## Application for Licence Amendment

<b>Licence Number</b>	L7404/1999/9
<b>Licence Holder</b>	Australian Nickel Investments Pty Ltd
<b>ACN</b>	111 599 323
<b>File Number</b>	DER2015/002781-1
<b>Premises</b>	Cosmos Nickel Operations Goldfields Highway SIR SAMUEL WA 6437  Legal description –  Mining tenements L36/118, L36/159, L36/171, L36/172, M36/127, M36/212, M36/365, M36/371, M36/375, M36/376, M36/377, M36/441, M36/659, and part of M36/180 and M36/349  As defined by the Premises maps attached to the Revised Licence
<b>Date of Report</b>	10 January 2023
<b>Decision</b>	Revised works approval granted

Figure 4: Location of monitoring bores and recovery bores

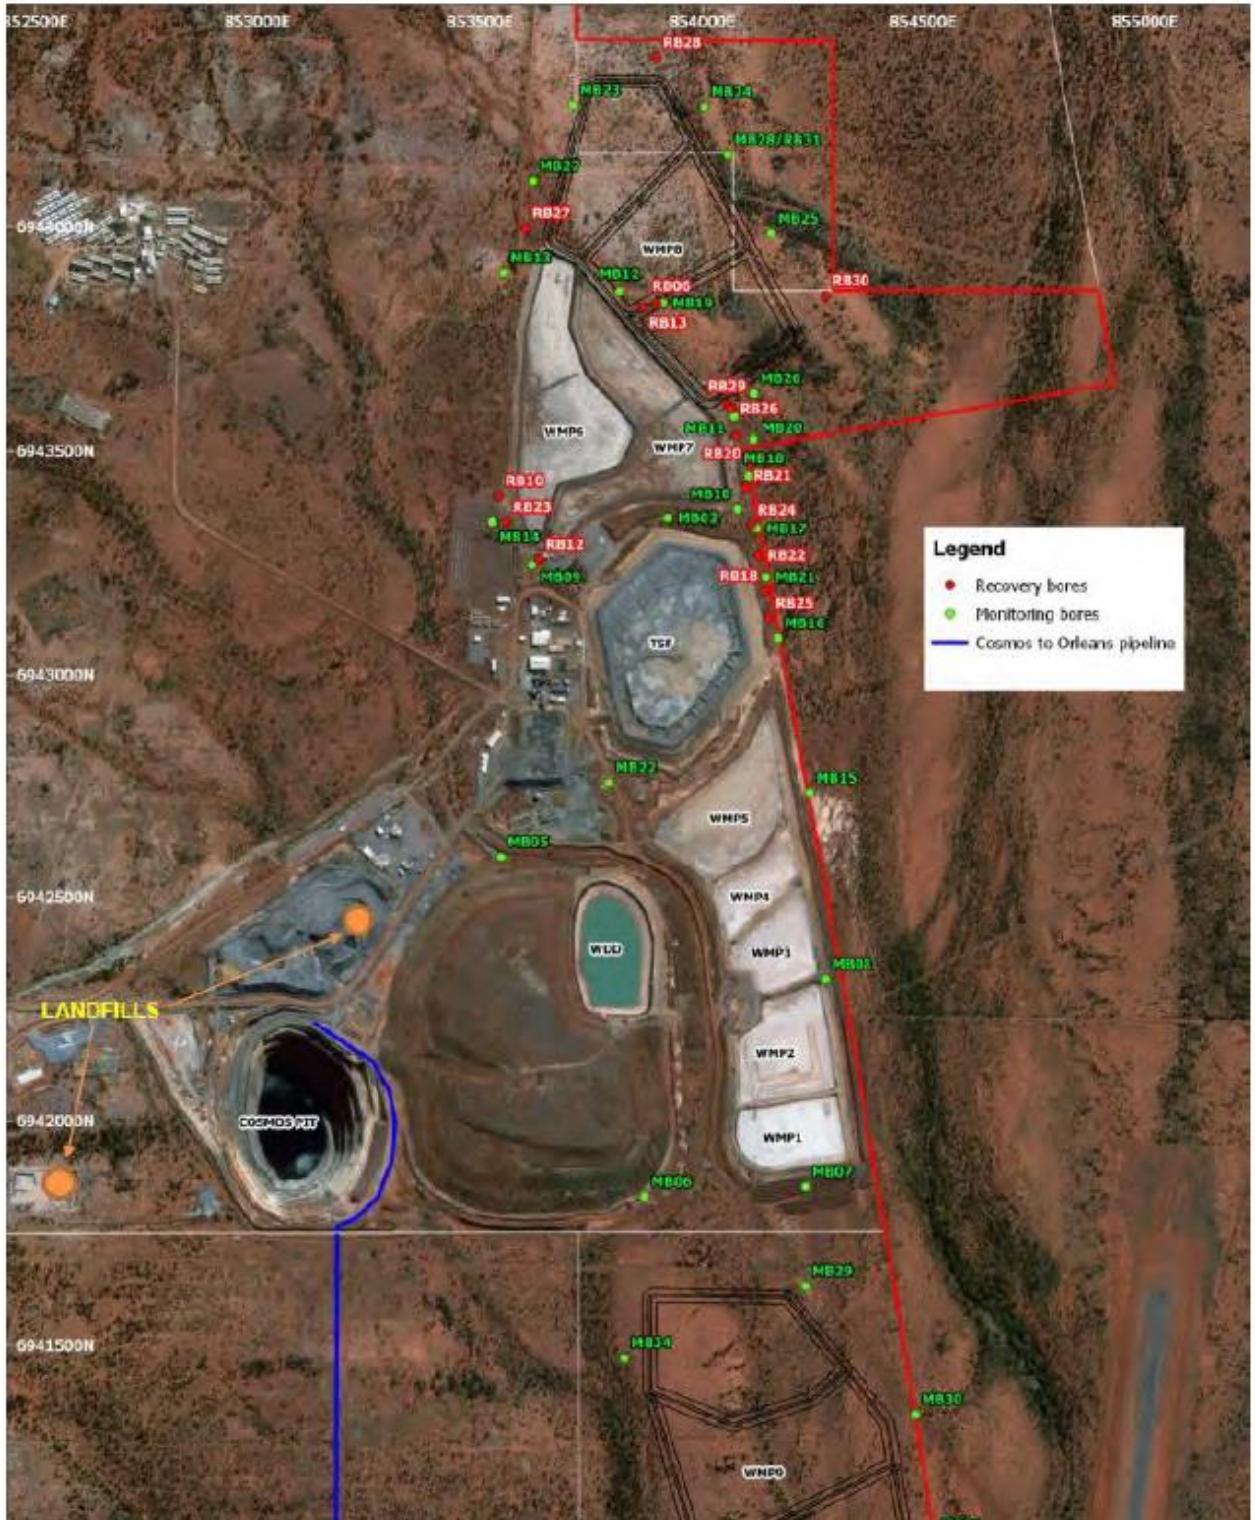
Condition 10 on the existing licence requires that the licence holder must undertake ambient groundwater monitoring at 18 monitoring sites. There is a groundwater action criterion for standing water level of <6 mbgl. The licence holder is also required to monitor pH, electrical conductivity and metals and metalloids from mounding impacts and water quality impacts at these 18 groundwater monitoring locations, see Figure 4.

Licence Holder was provided with draft amendment on 16/12/2022	<p>The Licence Holder provided the following comments on 24/12/2022:</p> <ol style="list-style-type: none"> <li>MB02 – Please see Attachment A an amendment #3 to licence L404 that was granted in 018. As detailed in this notice, MB02 was described as no longer serving the purpose of monitoring groundwater levels to protect vegetation to the north of the TSF. The amendment notice conditioned the replacement of MB02 with MB21, MB22, MB23 and MB24 to monitor / protect</li> </ol>	<ol style="list-style-type: none"> <li>Reference to MB02 has been removed and MB21, MB22, MB23 and MB24 are in place to monitor the impacts to vegetation.</li> <li>The SWL is noted.</li> </ol>

<p>vegetation to the north of the TSF. All these replacement bores remain active part of the compliance monitoring schedule detailed in the current licence.</p> <p>2. The Current SWL of MB02 is 5.5 mbgl. As above and in accordance with Attachment A, this relatively shallow groundwater condition (between action and compliance limit) is not representative of the receiving environment Note: the compliance limit for SWL is &lt;4mbgl.</p>	
--	---	--
